Subject: Response To Request For Additional Information -
10 CFR 20.2002 Request For Approval Of Disposal Of
Dredged Material

Oyster Creek Generating Station (Oyster Creek)
Facility Operating License No. DPR-16
NRC Docket No. 50-219

**RESPONSE TO NRC REQUEST FOR ADDITIONAL
INFORMATION - 10 CFR 20.2002 REQUEST FOR APPROVAL OF
DISPOSAL OF DREDGED MATERIAL**

Name: FORKED RIVER
Date: 11/14/98
Scale: 1 inch equals 2222 feet

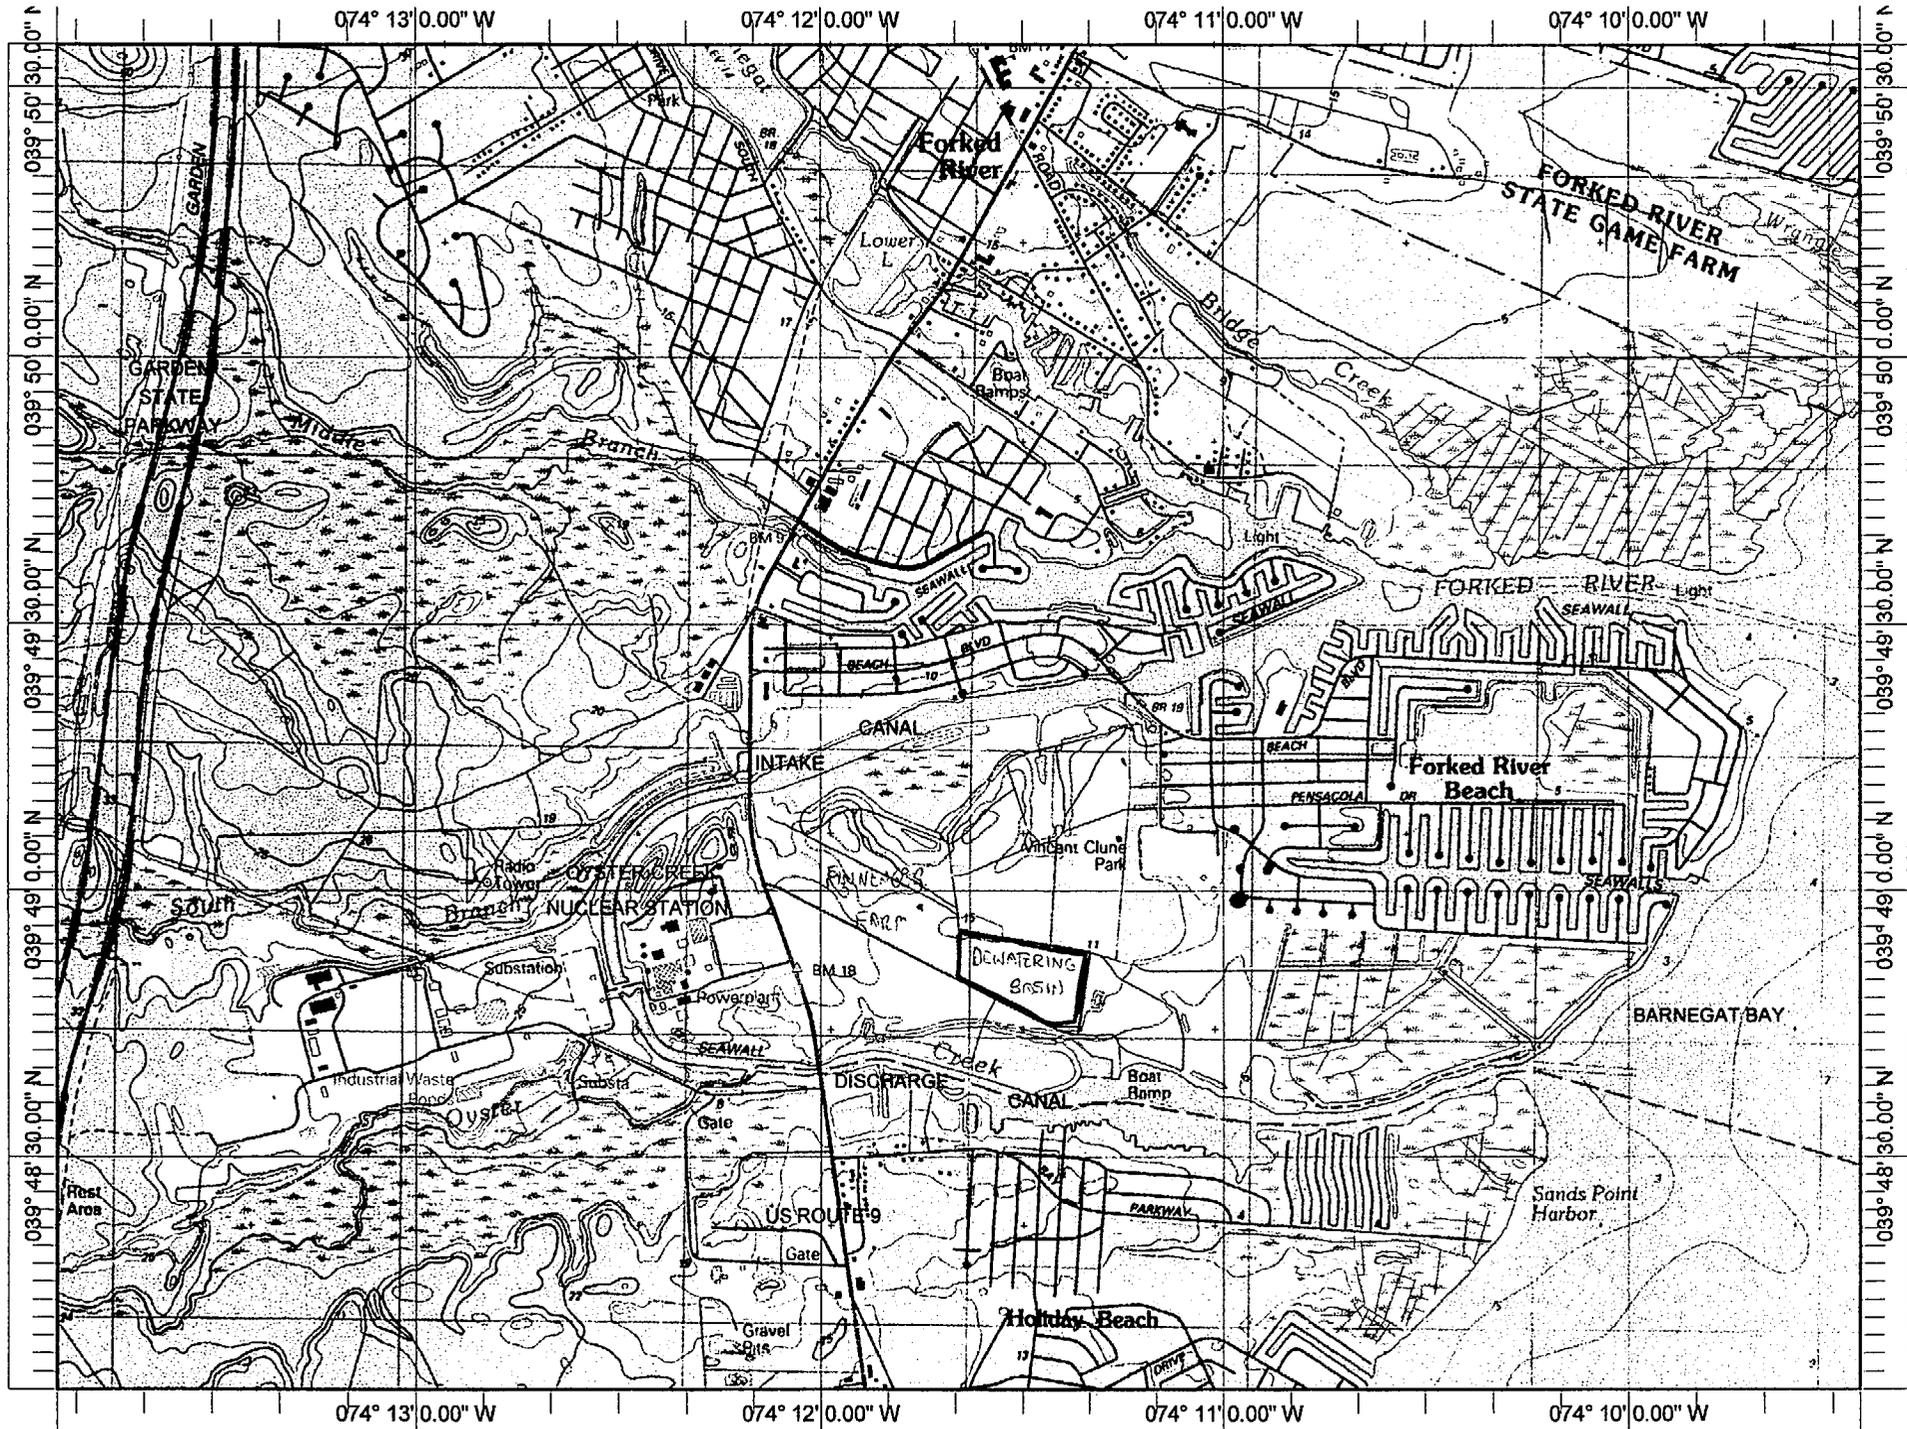
In 1978 Oyster Creek Generating Station (OCGS) dredged the intake canal (Forked River) and discharge canal (Oyster Creek). This was accomplished hydraulically with the dredged material disposed on an area (see attached map, Attachment 1) of approximately 17.5 acres. The dredged material consisted of fine and coarse sand with some silt and clay. As a result of the operation of OCGS, the dredged material contained low level licensed radioactive material. OCGS released effluents containing fission and activation products from 1969 to 1974. These effluents contained fission and activation products totaling 45 curies (see Attachment 5), and in 1978 isotopic analysis of silt samples at 5 locations in and around the intake and discharge canals indicated positive Co-60 and Cs-137. Therefore appropriate measures were taken to insure that the dredged material was contained. Since the licensed material had been discharged in accordance with the OC license and accounted for in OCGS semiannual reports *Radioactive Effluent Releases*, no additional action were taken. The disposal area was not located in wetlands and is characterized as generally level land of 14 to 18 feet elevation. As previously described in the original request, the 17.5 acre disposal area is located on approximately 600 acres known as Finninger Farm. This property is owned by the licensee and lies directly east of the Oyster Creek Generating Station's Controlled Area (see map, Attachment 1). The 600 acres were and are in various stages of field succession with mixed annual grasses being dominant vegetation. Prior to dredging, the area was cleared of vegetation and dikes/embankments were constructed around the areas to confine and retain the dredged material. Weirs and a spillway were constructed to allow the dredged water to drain off after settling of the dredged solid material. The plan assumed silt in the dredged material would form a seal in the base of the disposal area to prevent the intrusion of dredged water into the groundwater. After sufficient de-watering, the embankment material was used to cover the dredged material, graded and leveled to a height approximately 2 to 3 feet above existing grade. The area was re-vegetated and remained in the above state until some time in 1984.
